# STATE OF OHIO DEPARTMENT OF TRANSPORTATION

## GRE-68-12.65

XENIA TOWNSHIP

GREENE COUNTY

TRAFFIC CONTROL PLANS  
 LITTLE MIAMI SCENIC TRAIL AND NEW BRIDGE TRAIL

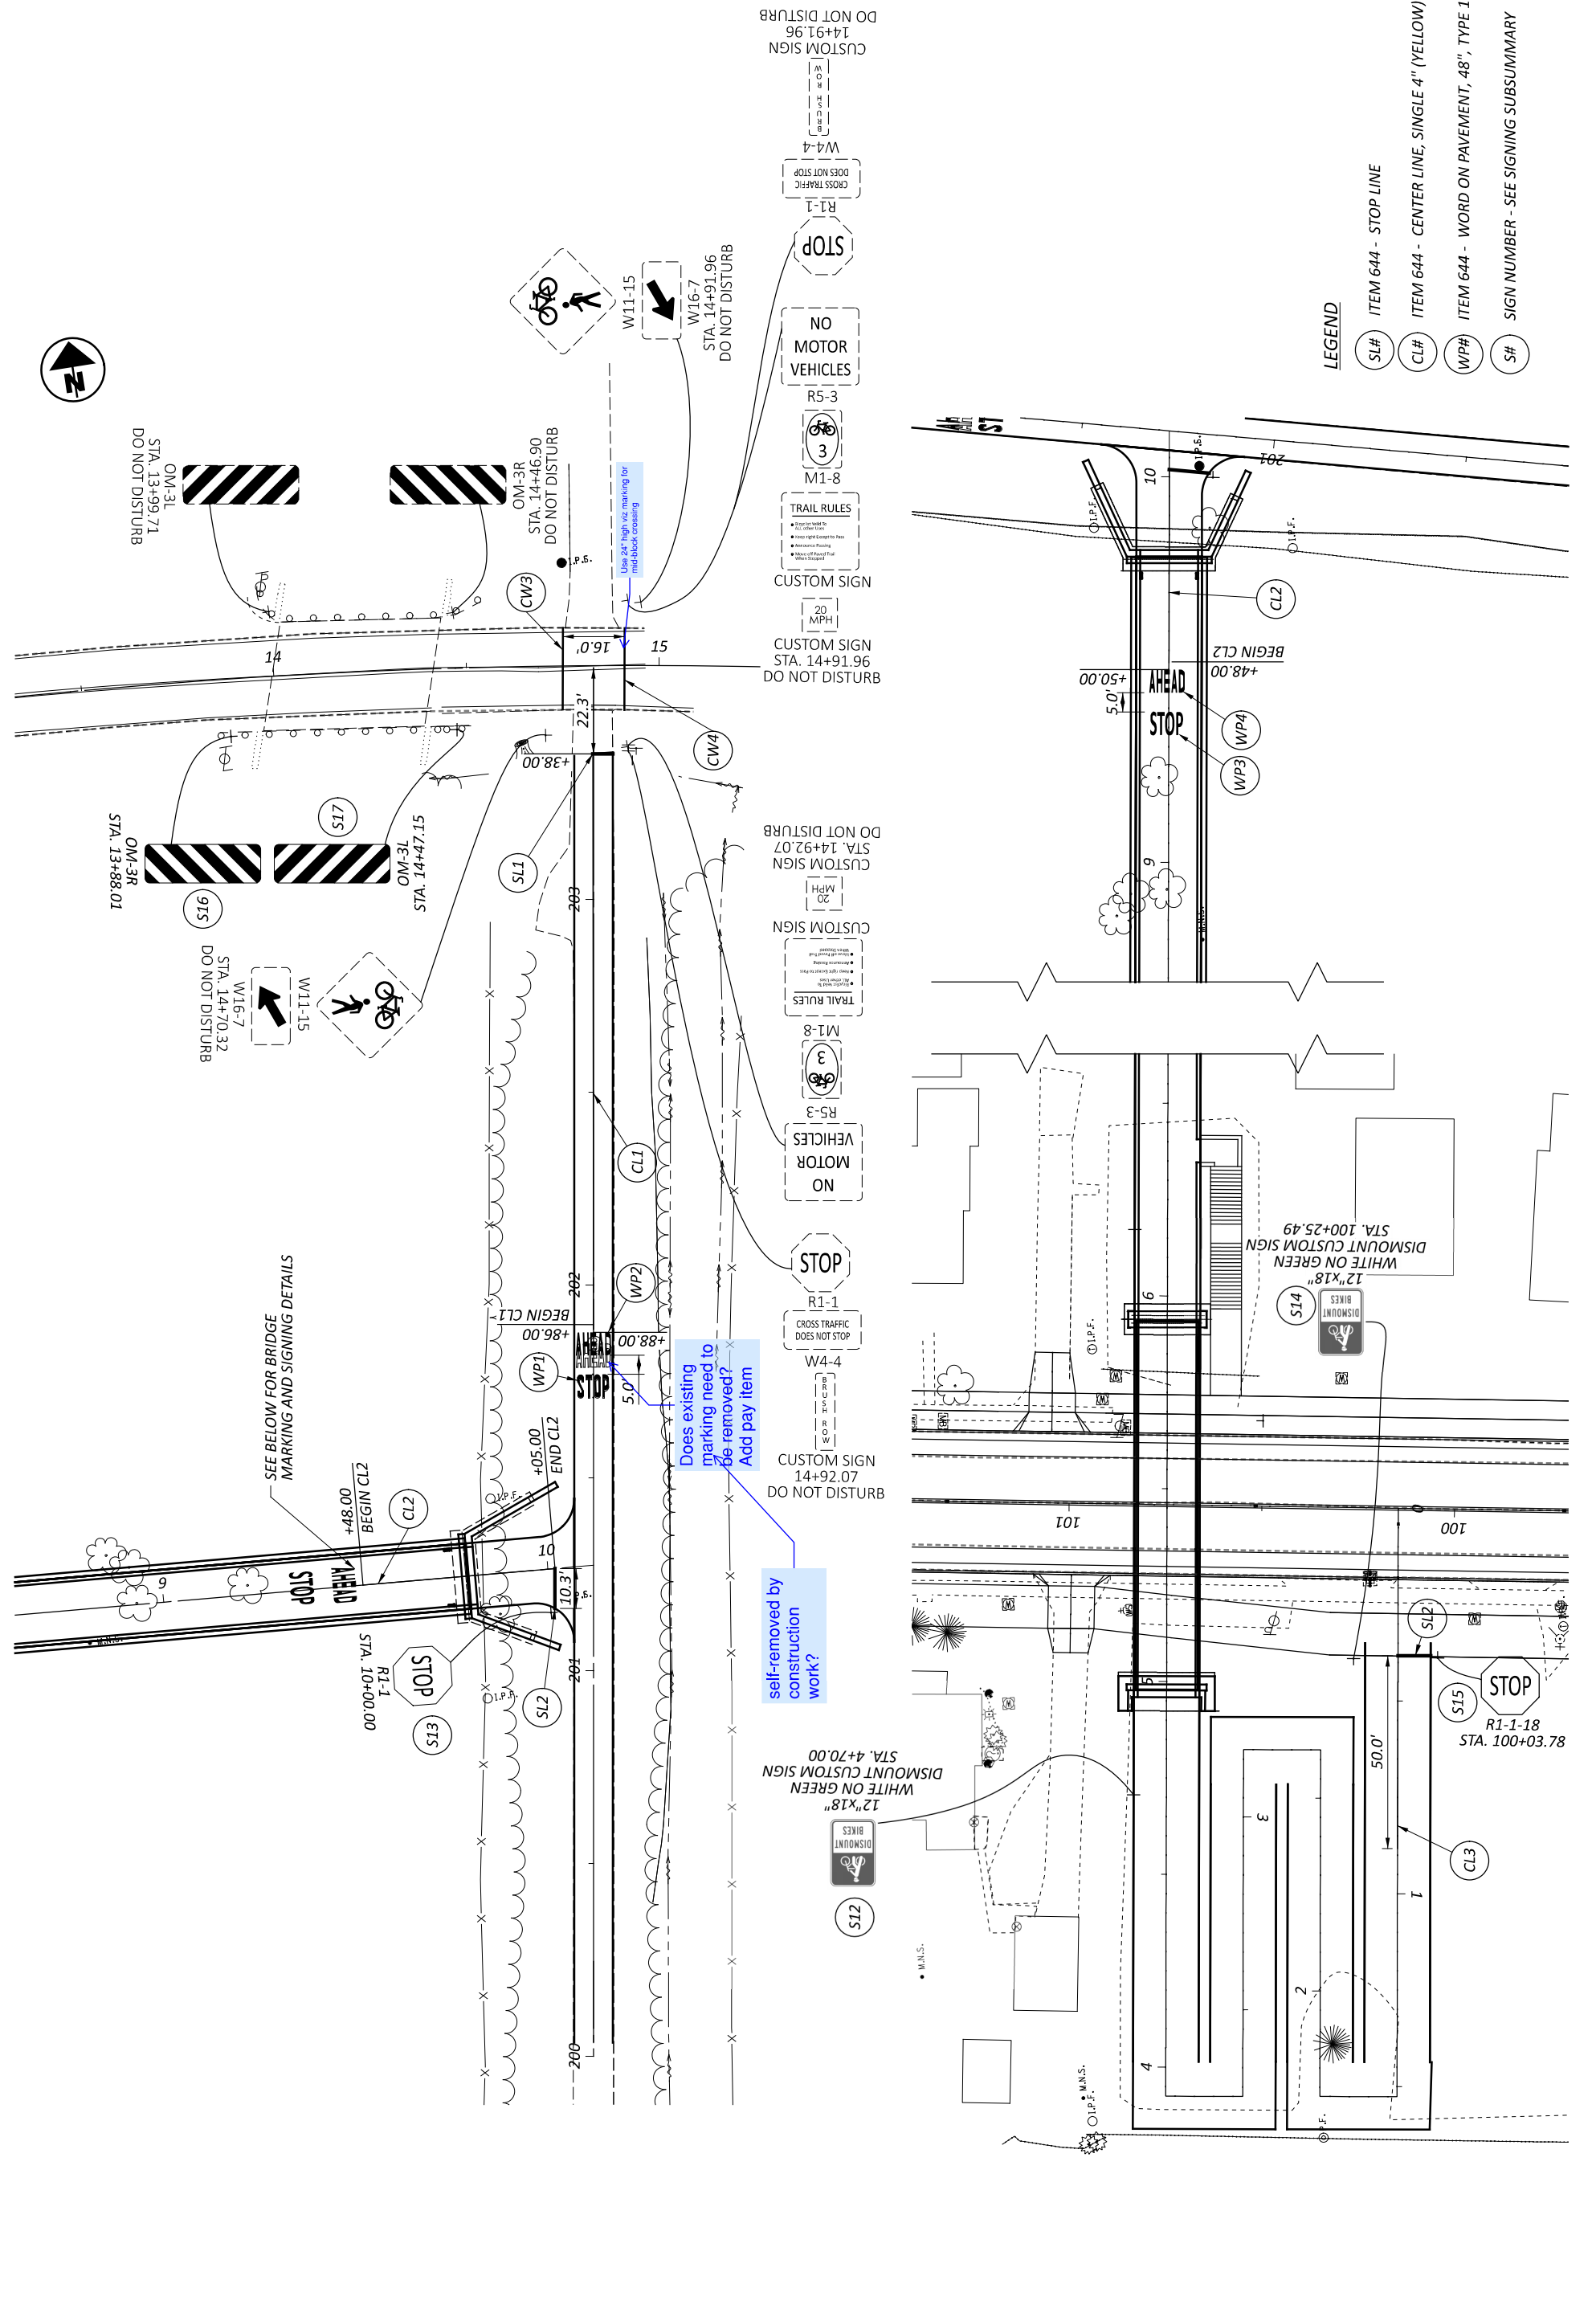
Does existing marking need to be removed?  
 Add pay item

PEDESTRIAN BRIDGE OVER U.S. 68  
 LIGHTING PLAN

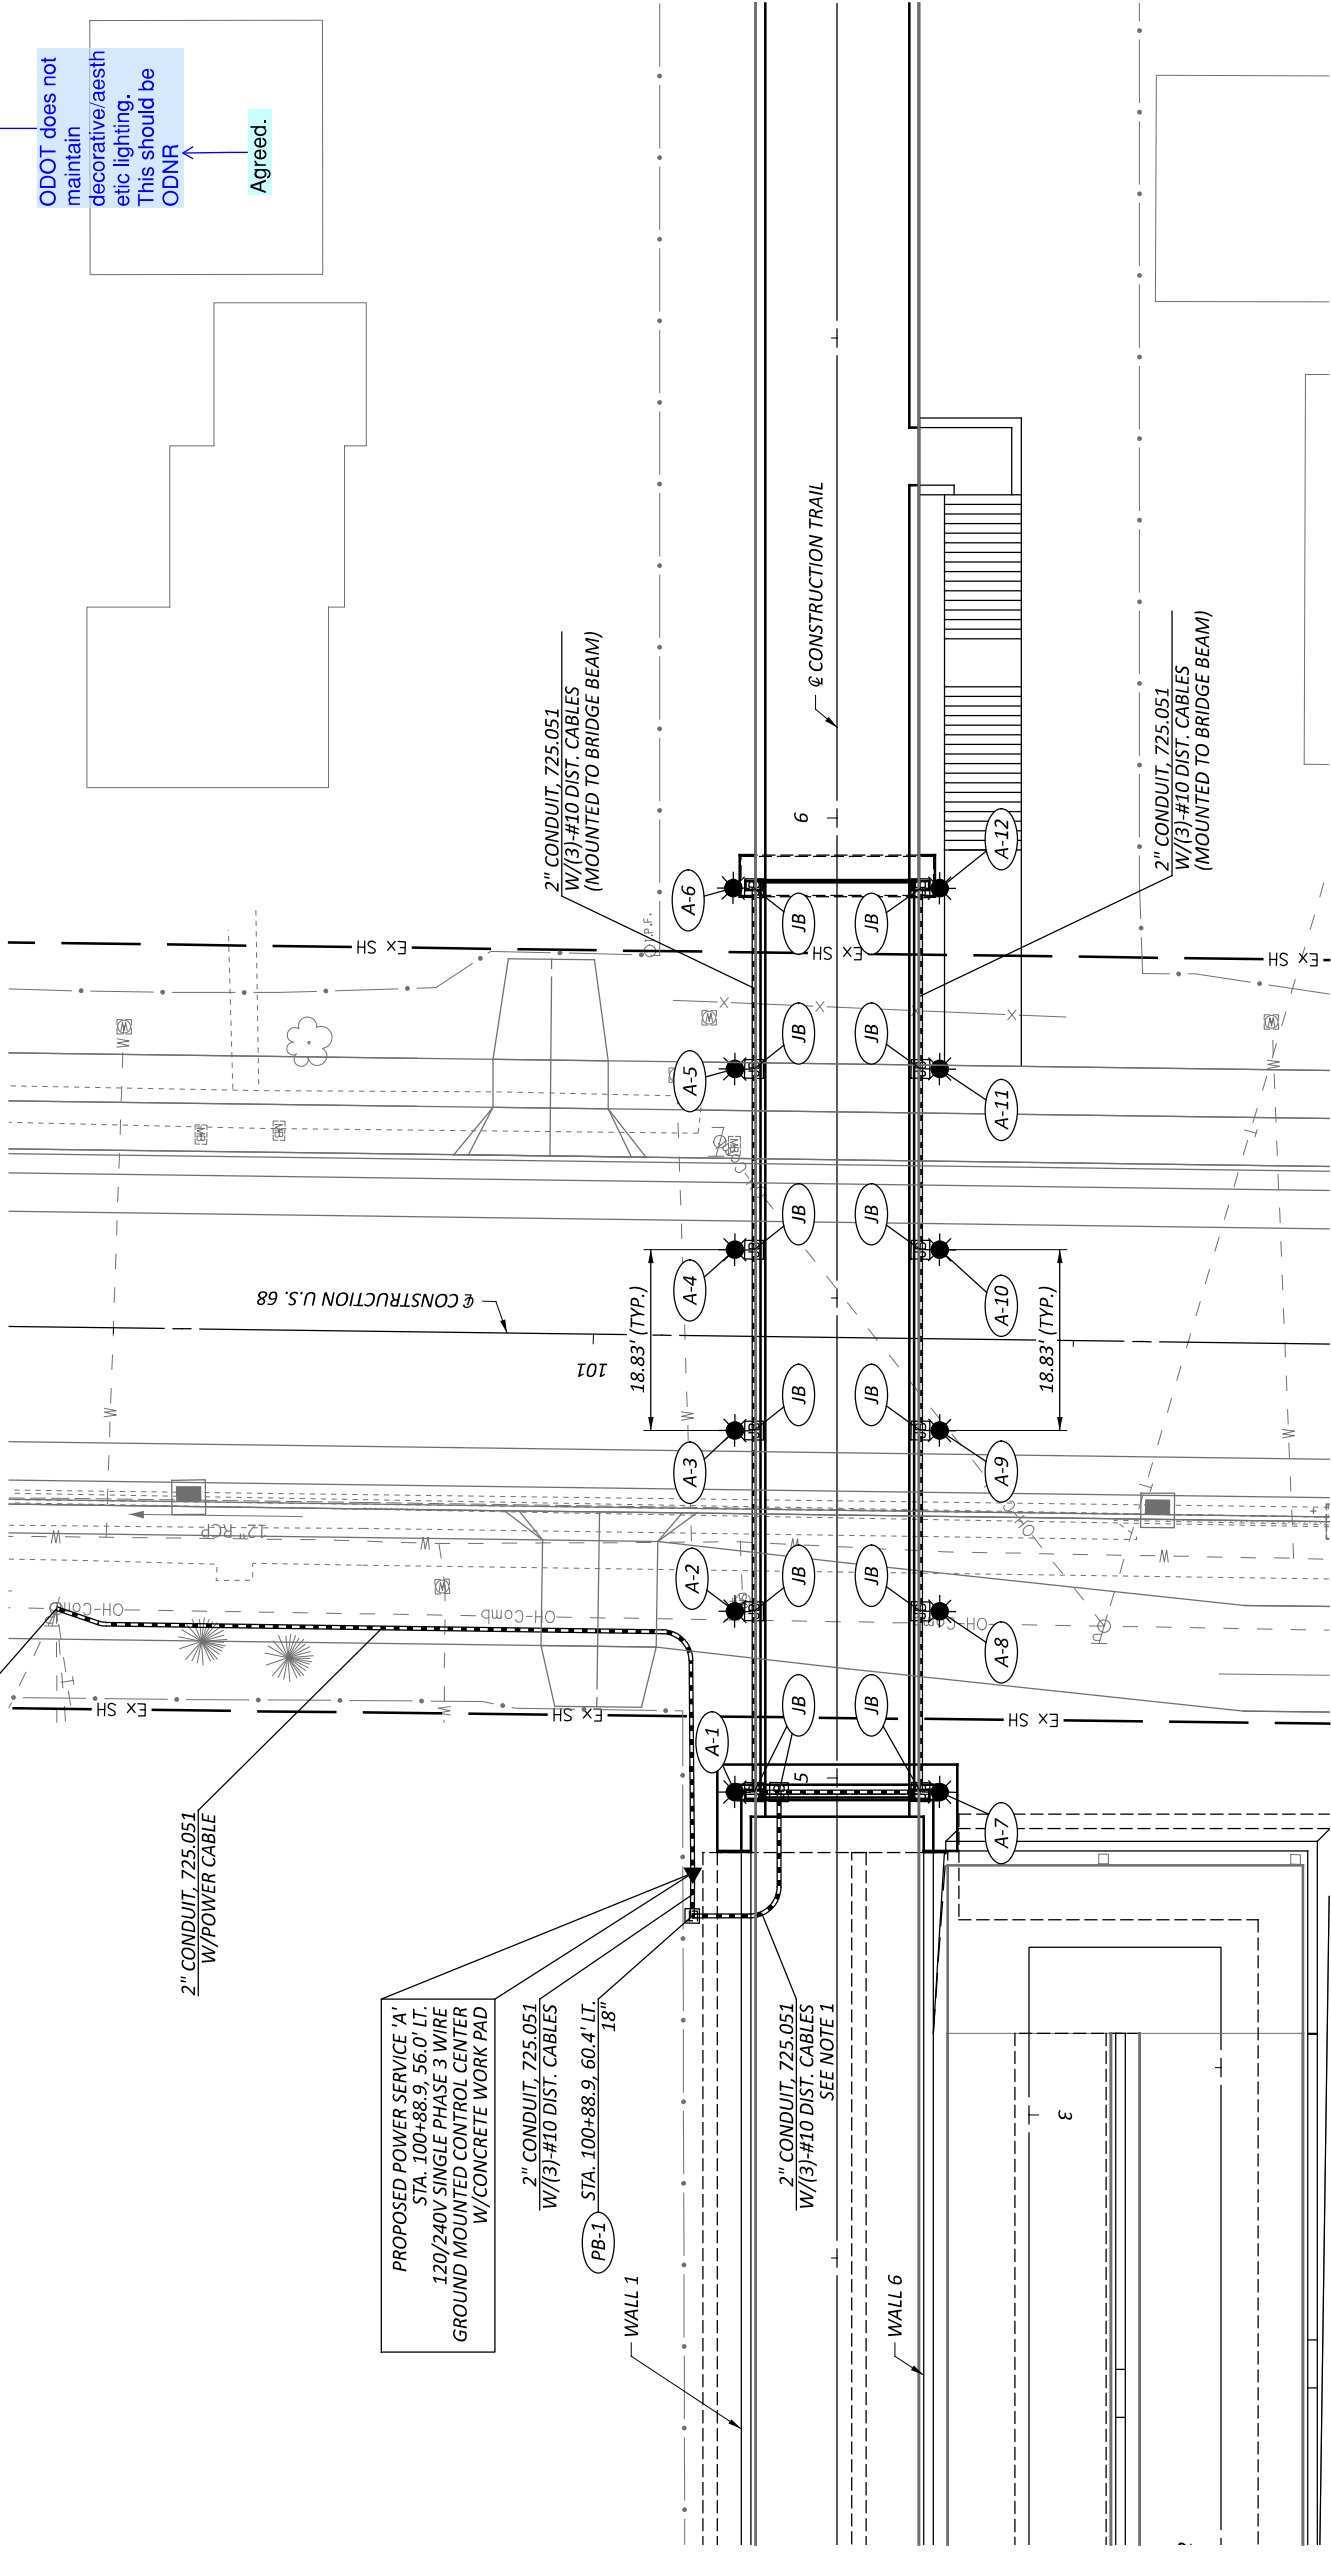
ODOT does not maintain decorative/aesthetic lighting. This should be ODNR  
 Agreed.
